**ADDENDUM #1**

**HERITAGE HIGH SCHOOL ADDITION AND RENOVATIONS**  
**2400 Granade Road**  
**Conyers, GA 30094**

**LPB 208059-H**

**SECTION 00 901**  
**AUGUST 20, 2009**

**SK1/AD311**

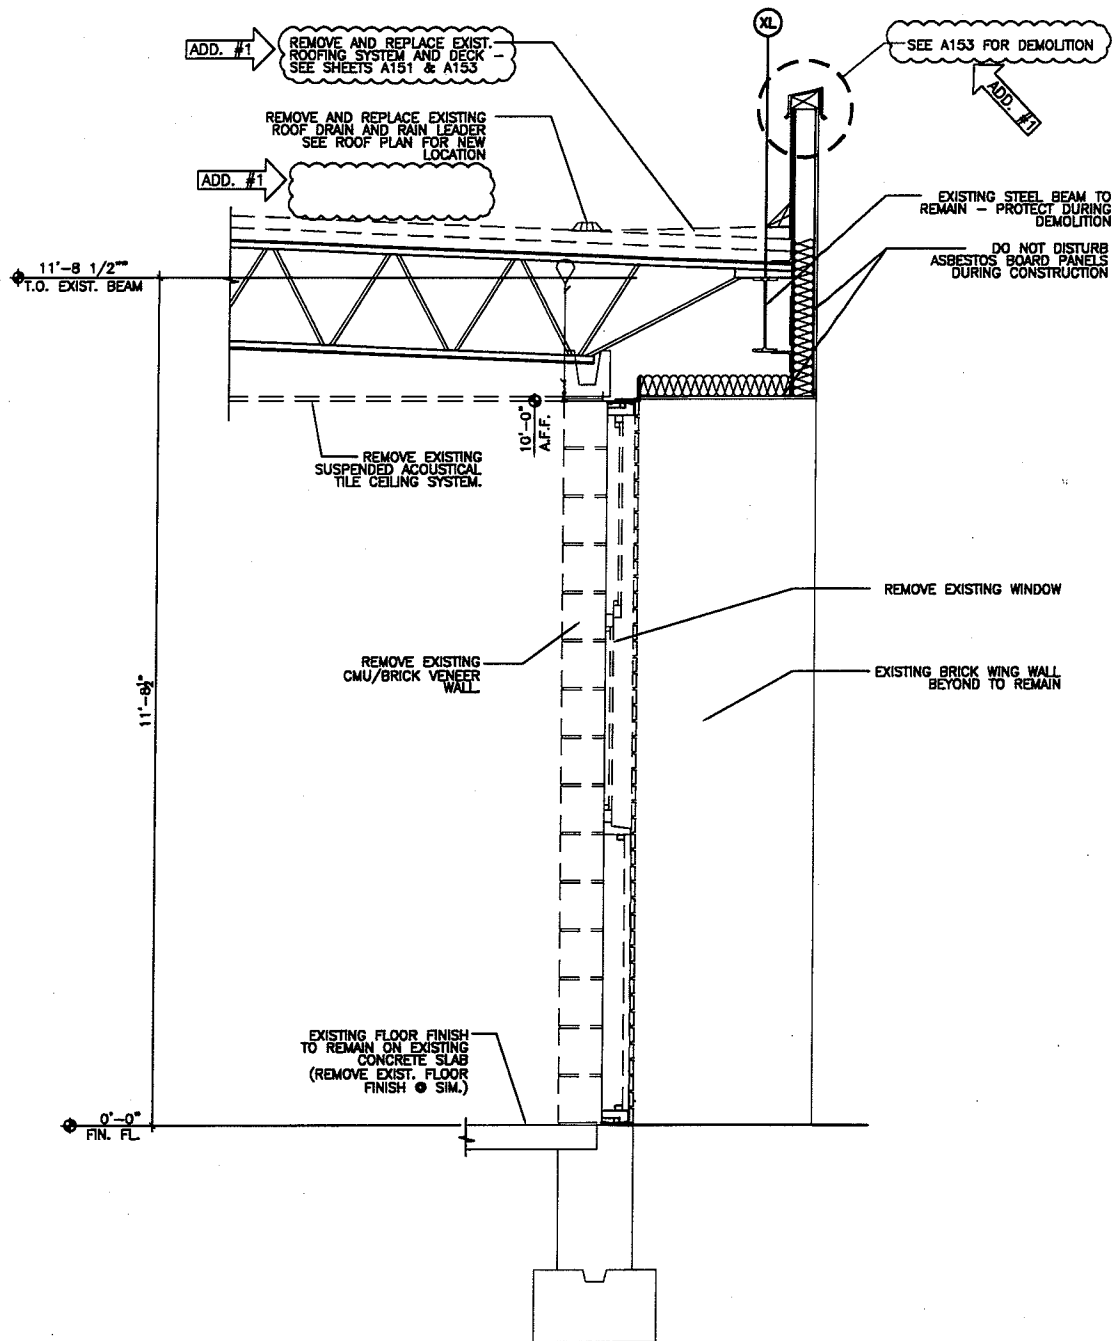
- A. Revise Detail 1 per attached Sketch SK1/AD311.  
B. Revise Detail 2 per attached Sketch SK2/AD311.  
C. Revise Detail 3 per attached Sketch SK3/AD311.

① DEMO SECTION @ EXIST. WINDOW  
 $\frac{3}{8}'' = 1'-0''$

PROJECT NO: 208059  
 ISSUE DATE: 8/4/2009  
 DATE: 8/20/2009  
 DRAWN BY: SL  
 CHECKED BY: BP  
 SHEET NO: **SK A102-A**

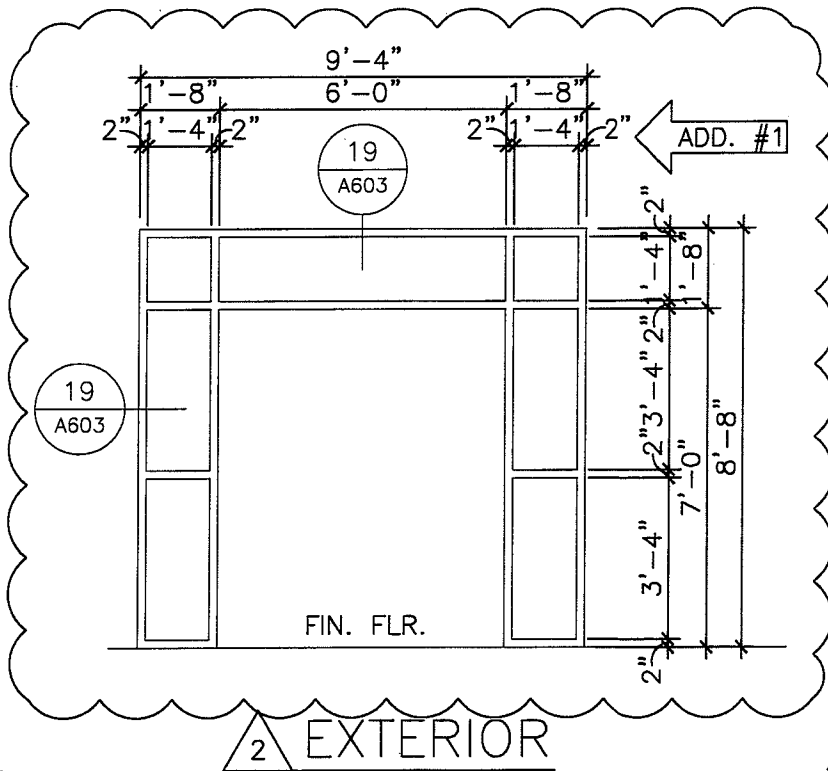
- A. Revise Wall Legend per attached Sketch SKA102-A.  
B. Revise Room Equipment Legend:  
1. Change Item #9 to "Counter Coiling Door".  
2. Change Item #11 to "Washer".  
3. Change Item #12 to "Dryer".  
4. Change Item #13 to "Uniform Storage Cabinet - Single Tier".  
5. Change Item #14 to "Uniform Storage Cabinet - Double Tier".

WALL LEGEND		
DTL.	TYPE	DESCRIPTION
		EXISTING WALL TO REMAIN
		NON-RATED CMU TO STRUCTURE AND/OR DECK ABOVE
		NON-RATED CMU TO 14" ABOVE CEILING
		BRICK VENEER
		NON-RATED CMU TO 6'-0" A.F.F.
ADD. #1		NEW 1 HR. F.R. WALL FIRESTOP ALL PENETRATIONS
		EXISTING 1 HR. F.R. WALL - FIRESTOP ALL PENETRATIONS

**SK2H/A603**

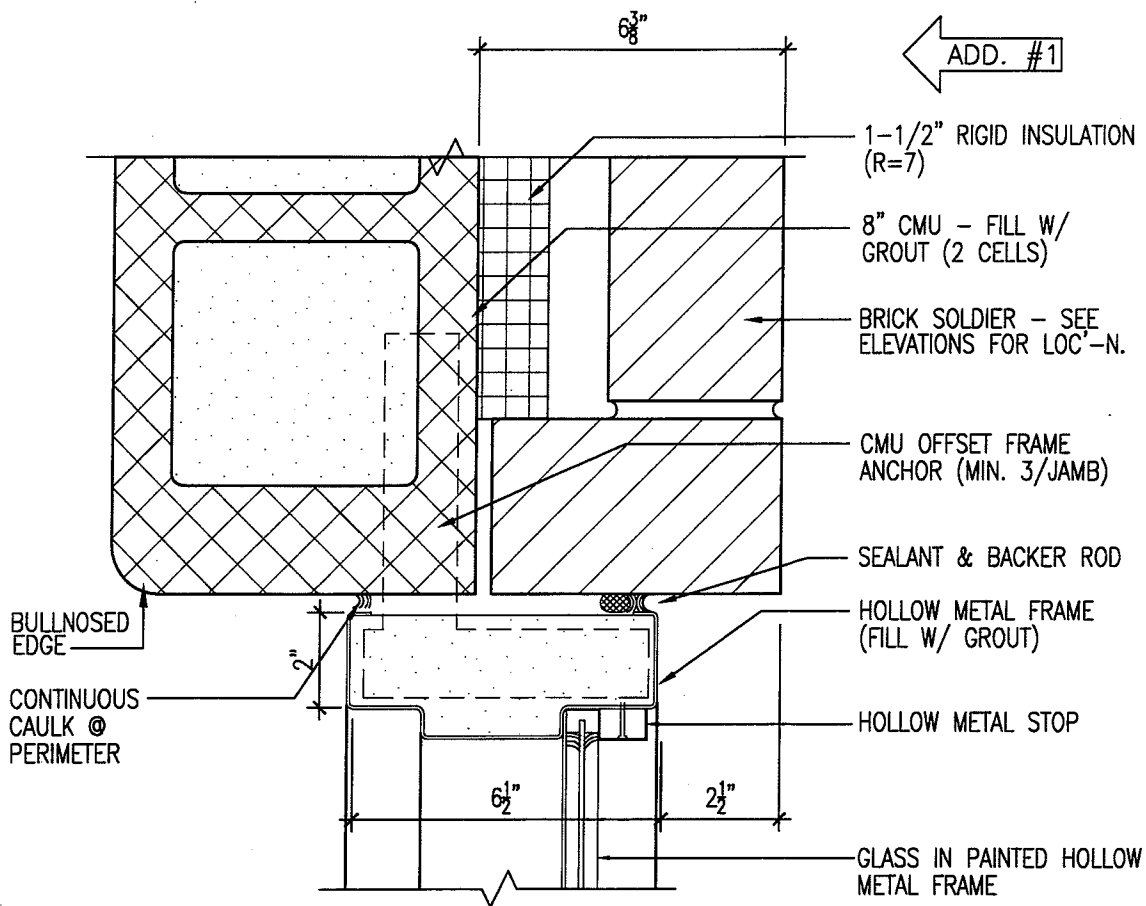
- A. Revise Hollow Metal Frame Elevation #2 per attached Sketch SK2H/A603.
- B. Change Storefront Elevation Type 7 to Type "B".
- C. Change Storefront Elevation Type 8 to Type "A".
- D. Add new Detail 19 "H.M. Window @ Exterior" per attached Sketch SK19/A603.

# HOLLOW METAL FRAME ELEV.

PROJECT NO: 208059  
 ISSUE DATE: 8/4/2009  
 DATE: 8/20/2009  
 DRAWN BY: SL  
 CHECKED BY: BP  
 SHEET NO: **SK2/A901**

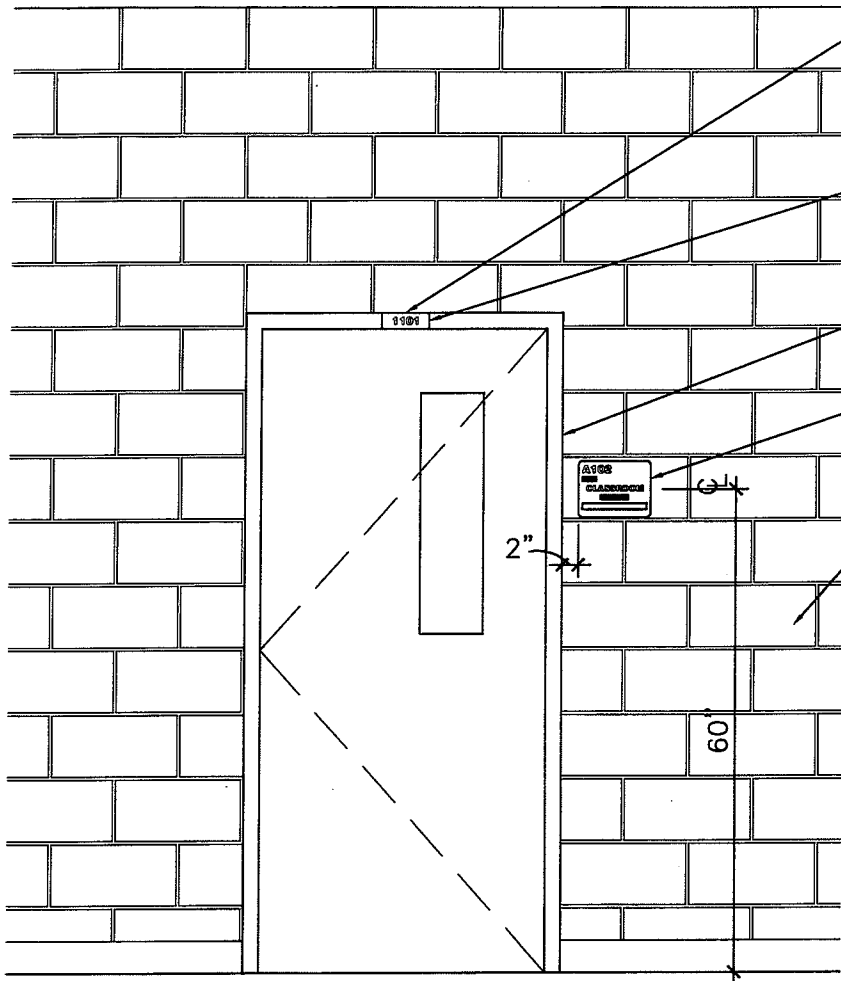
- A. Add Signage Elevation Detail #2. See attached Sketch SK2/A901.

REMOVE & DISCARD EXISTING SIGN @ EXISTING DOOR HEAD. BONDO HOLES AND PREP FOR PAINT

INVENTORY SIGN ATTACHED TO DOOR FRAME DESIGNATED BY A RECTANGLE **1101** ON FLOOR PLAN

SAND EXISTING DOOR FRAMES SMOOTH AND PAINT

ROOM SIGN DESIGNATED BY AN OVAL **A102** ON FLOOR PLAN

**2** TYP. CLASSROOM DOOR SIGNAGE ELEVATION  
 1/2" = 1'-0"  
 @ NEW & EXISTING DOORS
